UNITED STATES PATENT AND TRADEMARK OFFICE

APPLICATION NO.	FILING DATE	FIRST NAMED INVENTOR	ATTORNEY DOCKET NO.	CONFIRMATION NO.
10/617,328	07/10/2003	Yasuhiro Miki	9281/4608	2828

Office Action Summary	Application No.	Applicant(s)	
	10/617,328	MIKI ET AL.	
	Examiner	Art Unit	
	Michael H. Caley	2871

DETAILED ACTION

FIG. 26

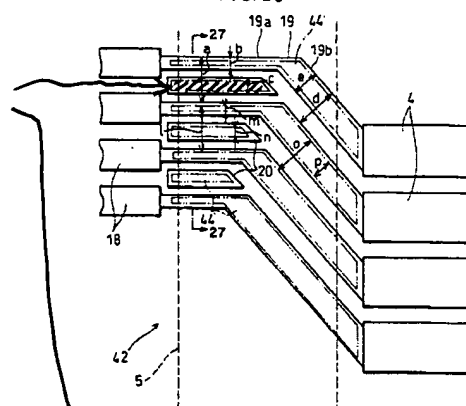
a transparent dummy electrode provided for controlling the gap at a position on the other substrate opposite to a connection portion between the transparent electrodes and the lead wirings on the one substrate (Figures 26 and 27 element 44, beneath element 20);

wherein the transparent dummy electrode is formed to avoid positions opposite to the connection portions (Figures 26 and 27).

Regarding claim 2, Nakahara discloses the transparent dummy electrode (Figures 26 and 27 element 44, beneath element 20) is also provided on portions opposite to spaces between the ends of the transparent electrodes on the one substrate.

Regarding claim 3, Nakahara discloses the transparent electrodes on the one substrate as wider than the lead wirings (Figure 26 elements 19 and 4; Column 8 lines 5-24).

Applicant states that Nakahara fails to disclose the lead wirings (Figure 26 element 19) as metal lead wirings because they are disclosed as composed of "indium tin oxide, or the like". The examiner maintains, however, that the lead wiring is a metal lead wiring since indium tin oxide is generally regarded as an example of a metal material within the art (See U.S. Patent No. 5,557,436 to Blose et al., Column 4 lines 10-16. U.S. Patent No. 6,459,463 to Kim et al. and U.S. Patent No. 5,969,782 to Lee et al. contain further examples of indium tin oxide exemplified as a metal).

The examiner maintains, however, that the abutting junction between elements 19 and 4 represents a connection portion given the physical contact and electrical conductivity between the two elements. Furthermore, the examiner fails to recognize any structural distinction between the terms “connected portions” and “connection portions”.

Applicant asserts that Nakahara fails to disclose “the transparent dummy electrode as formed to avoid positions opposite to the overlap portions”. The examiner disagrees and maintains that the reference discloses a transparent dummy electrode accordingly. The claim language discloses a single dummy electrode positioned as proposed. Nakahara discloses such a dummy electrode (44 beneath element 20) as formed opposite another dummy electrode (20) (Figures 26 and 27 element 44 beneath element 20). The same dummy electrode (44) is not positioned opposite an overlap or connection portion.

This electrode avoids positions opposite to overlap portions
